## **ADDENDUM NO. 2**

**DATE:** October 17, 2019

**SUBJECT:** Invitation to Bid – ITB20-011 Nikiski Fire Station No. 3

Date: FEB. 7, 2019  
 Drawn: MCM  
 Checked: CMP  
 Project: 1168.DWG  
 File Name: 1168.DWG  
**Sheet Title:**  
 SCHEDULES  
**Sheet:**  
 A2.1  
 9 of 37A

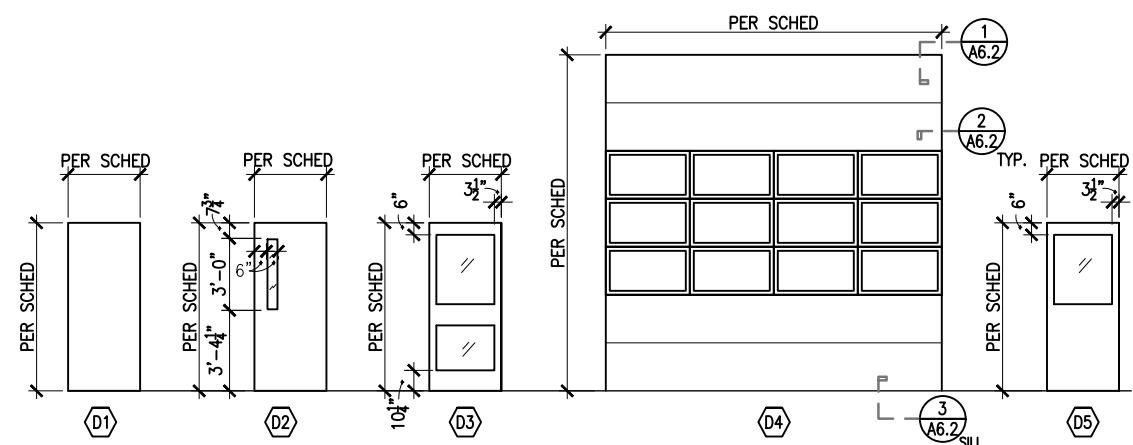
| 02-04 | Plan Holder Question | <p>Q: Finish Schedule sheet A2.1 indicates rooms 112 &amp; 113 are to receive C-5 Tectum ceiling panels. Sheet A7.1 indicates rooms 112-113 are to be exposed. Please clarify the RCP finish at Rooms # 112 &amp; 113?</p> <p><b>A: Please see the revised sheet A2.1, Finish schedule Rooms 112 and 113 shall receive finish C-4. Ceilings are to be exposed to structure with painted finish.</b></p>  |
| 02-05 | Plan Holder Question | <p>Q: Second Floor RCP Sheet A7.2 appears to indicate Tectum ceiling panels at Room #211. The Finish Schedule Sheet A2.1 indicates room #211 is to have the C-4 ceiling finish. Please clarify the Tectum Ceiling Panels are at room #211?</p> <p><b>A: Please see the revised sheet A2.1, Finish schedule Room 211 shall receive finish C-5. Ceilings are to be painted per C-4 and receive Tectum Ceiling Panels as shown on sheet A7.2.</b></p>   |
| 02-06 | Plan Holder Question | <p>Q: There is a discrepancy between specification sections (09 51 10 2.02.B), (09 51 10 2.02.C), the Finish Schedule on Sheet A2.1, and the RCP Sheets A7.1 &amp; A7.2.</p> <ul style="list-style-type: none"><li>a. Specification section (09 51 10 2.02.B) lists ACT-1 as Cirrus #581 - 2x2 tile, but the RCP hatching on Sheets A7.1 &amp; A7.2 show ACT-1 as a 2x4 tile.</li><li>b. Specification section (09 51 10 2.02.C) lists ACT-2 as Fine Fissured #1729 – 2x4 tile, but the RCP hatching on Sheets A7.1 &amp; A7.2 show ACT-2 as a 2x2 tile.</li></ul> |

<p>c. The ceiling type "C-3" that is listed for various rooms on the Finish Schedule Sheet A2.1, do not match the hatching callouts on RCP Sheets A7.1 &amp; A7.2.</p> <p>d. Please clarify the ceiling types and corresponding ACT types with respect to the Finish Schedule Sheet A2.1, RCP Sheets A7.1 &amp; A7.2, and the specification sections (09 51 10 2.02 B) &amp; (09 51 10 2.02 C)</p> <p><b>A: Please see the revised sheets A2.1, A7.1 and A7.2 showing the correct ceiling types corresponding with the Reflected Ceiling Plan and Specifications.</b></p>
02-07	Plan Holder Question	<p>Q: Please revise Finish Schedule Ceiling types to Include the Type C-2 ceiling types 2x2 Cirrus#581.</p> <p><b>A: Please see the revised sheet A2.1 showing the correct ceiling types corresponding with the Reflected Ceiling Plan and Specifications.</b></p>
02-08	Plan Holder Question	<p>Q: Request for substitution for CertainTeed Northgate SBS shingles.</p> <p><b>A: Please provide a formal substitution request form on as provided in specification section 01 63 00 Product Options and Substitutions.</b></p>
